# Memorandum to the City of Markham Committee of Adjustment

February 6, 2019

**File:** A/167/18  
**Address:** 41 Hawkrigde Ave, Markham  
**Applicant:** Jie Zhou  
**Agent:** Vince Emam Jomeh  
**Hearing Date:** Wednesday February 20, 2019

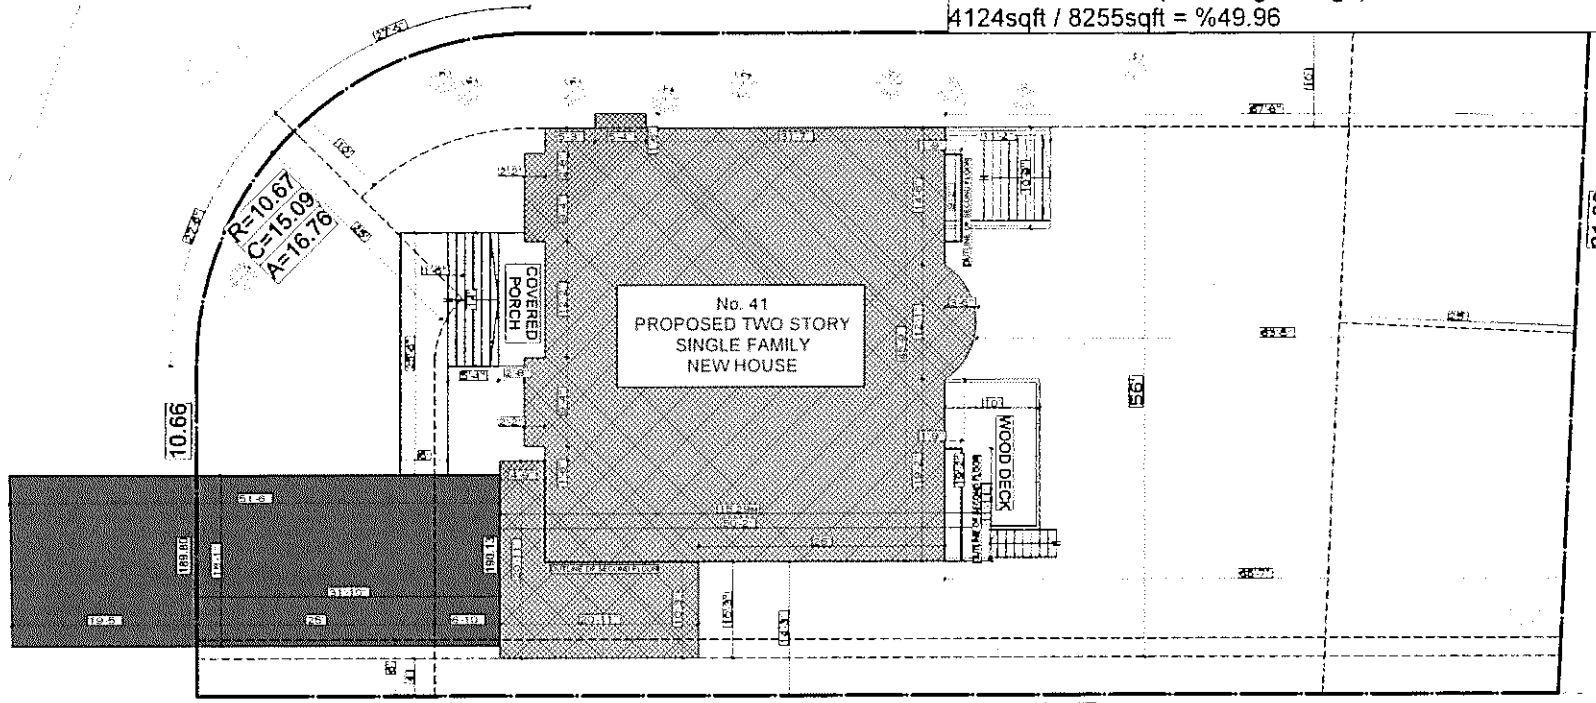
a maximum floor area ratio (FAR) of 49.96 percent, whereas the By-law permits a maximum FAR of 45 percent; as it relates to a proposed two storey detached dwelling.

DRAWING TITLE  
ROOF

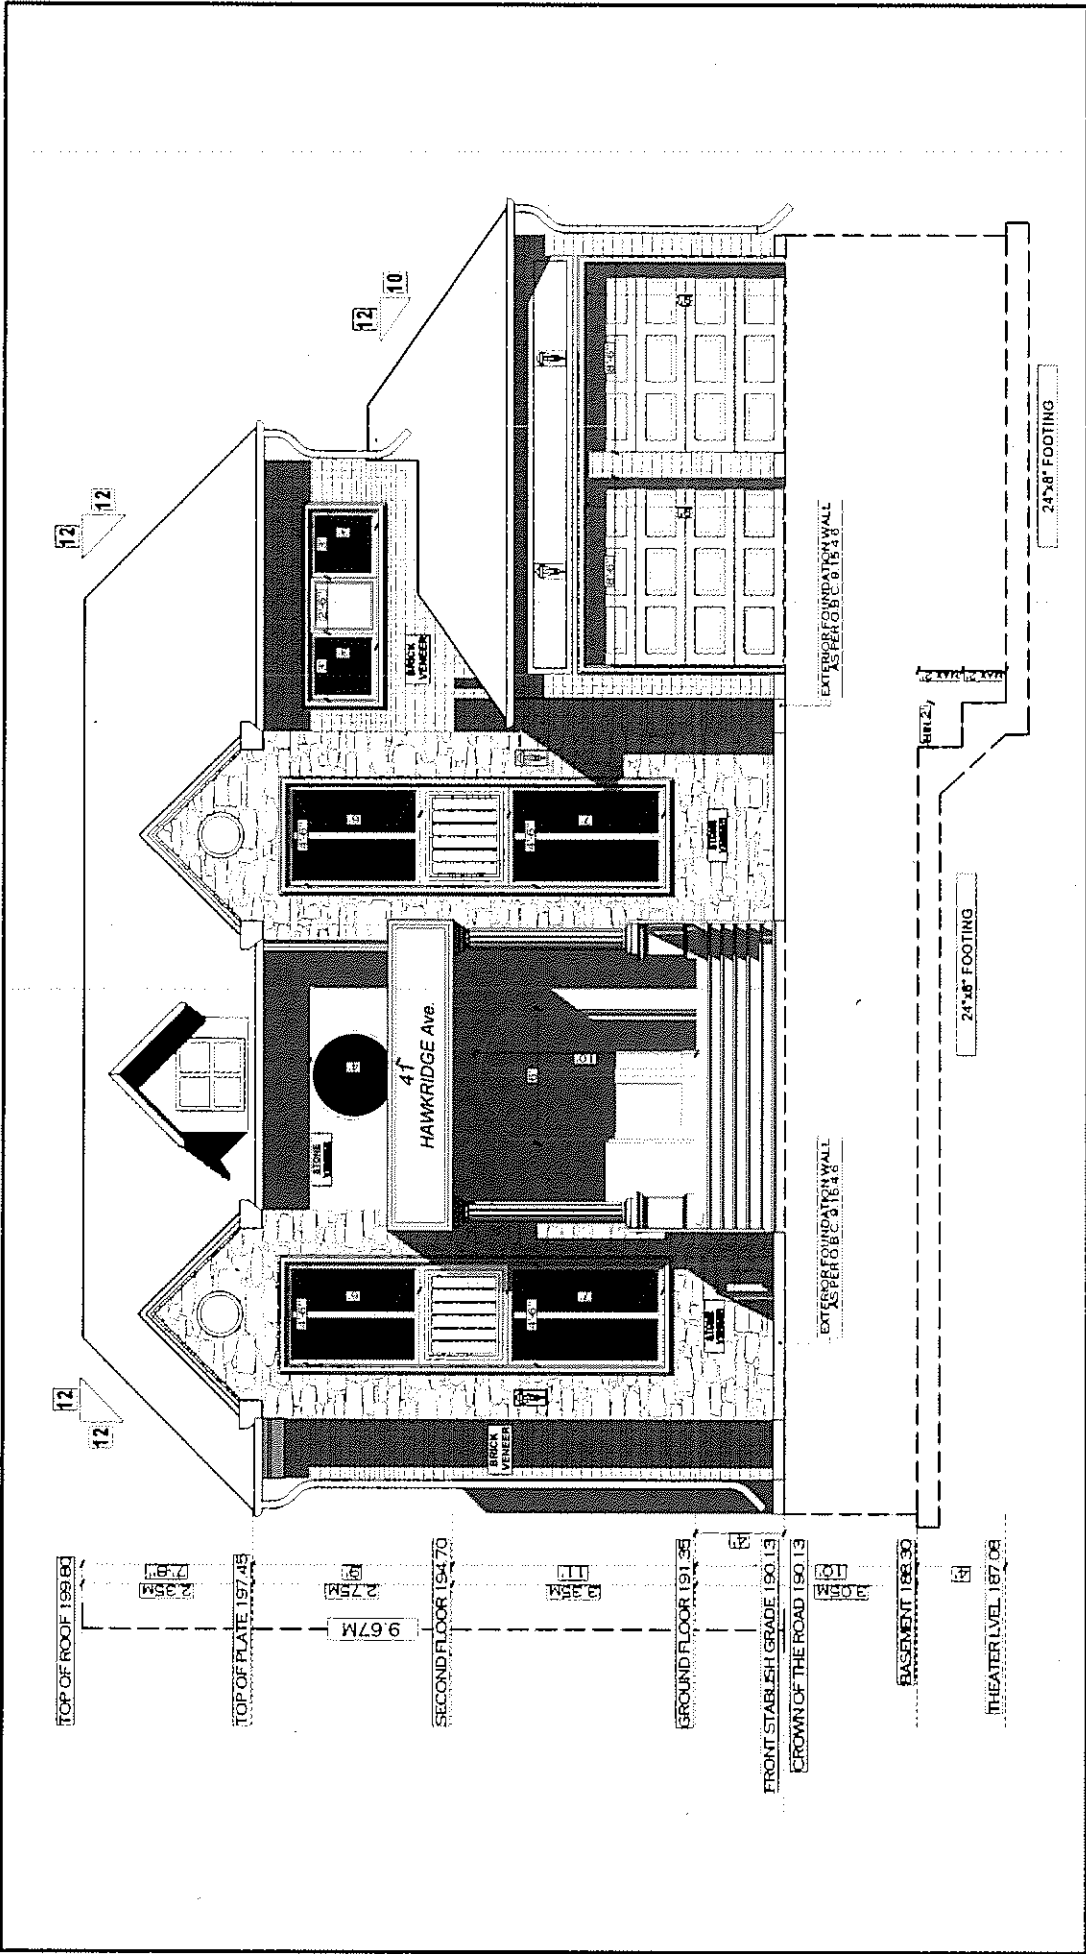
The Committee of Adjustment deferred the application on January 23, 2019, due to concerns regarding the roof design of the proposed dwelling. In response to the Committee of Adjustment's comments, the applicant submitted revised drawings on January 30, 2019 (Appendix B2) showing a revised design of the roof and removal of the front balcony. Staff comments dated November 20, 2018 (Appendix 'C2') are still applicable.
